STAFF REPORT

Diamond Estates, Fourth Filing **Summation**

Final Subdivision Plat Process

CASE NUMBER(s): UDC-13-00035

FINAL PLAT OF DIAMOND ESTATES FOURTH FILING

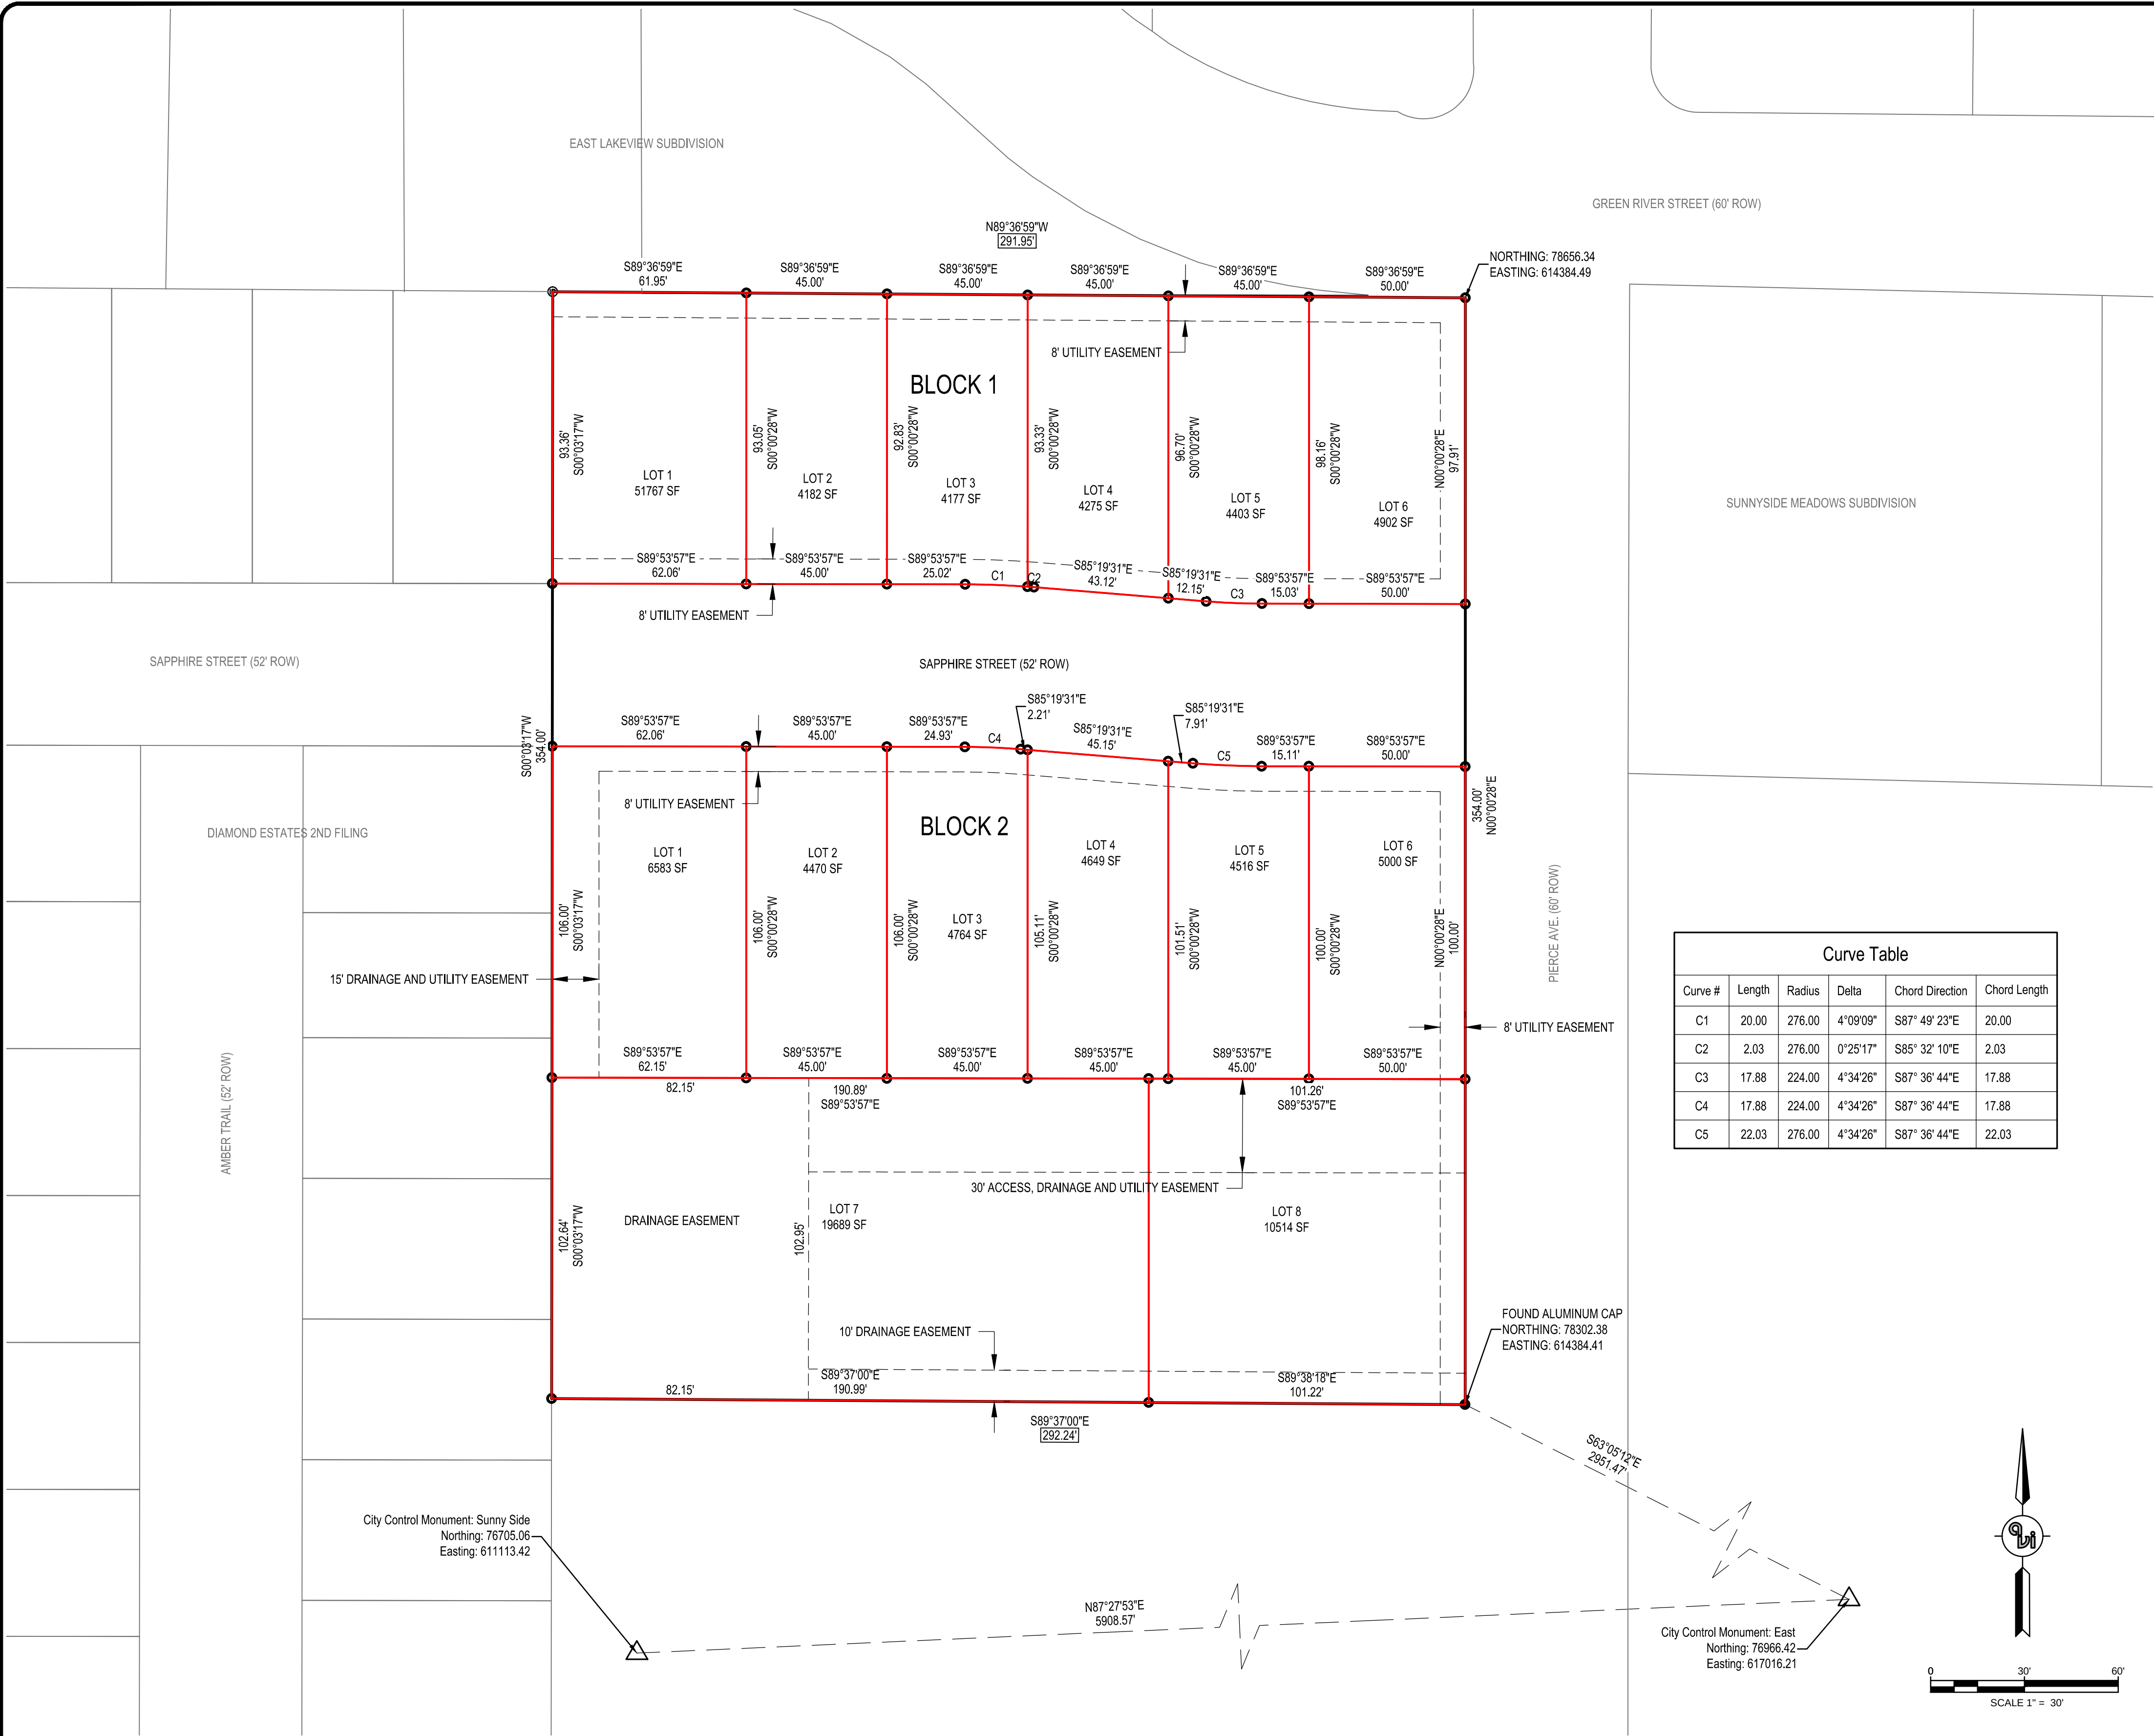
1. The coordinates provided for the "TRUE POINT OF BEGINNING" appears to have a digit missing in the easting. Reads 61438.41 presently, but I believe should read 614384.41. This is required to be corrected.

2. The second set of coordinates provided are on the NW corner of the proposed subdivision. However, City Code requires that the second set of coordinates provided should be on the other end of "one course". In this case that would be either the NE or SW corners, neither of which is provided. So coordinates need to be provided for either the NE or SW corners. This is required.

3. In the LEGAL DESCRIPTION the distance in the closing course presently reads 192.14', which would be a misclosure, but the map shows a distance of 292.24', which closes correctly. This correction is required.

4. In my opinion the map boundary bearing orientation ought to read the same as the LEGAL DESCRIPTION boundary bearing orientations. For those of us in the industry it is easily understood; for John Q. Public it is confusing and disorienting. This is not a requirement, only a suggestion.

5. The Laramie County Clerk's Office is presently using a 1" x 4" block for a printed "FILING RECORD" to be attached to the plat at recording. They no longer use the old "FILING

RECORD” block as provided. I may suggest modifying that at this time. Although, I don’t think the City instructions have been modified to reflect this change yet either. I will follow up on this end as well.

The submitted Plat map is incomplete (plat does not meet the review criteria from UDC 2.1.2.d. 1 & 3) as it does not show adjacent streets and subdivision lot lines to the east. **NOTE:** *Resolved. Revised Map submitted on 2/12/2013.*

NOTE: *Resolved. Revised Map submitted on 2/12/2013.*
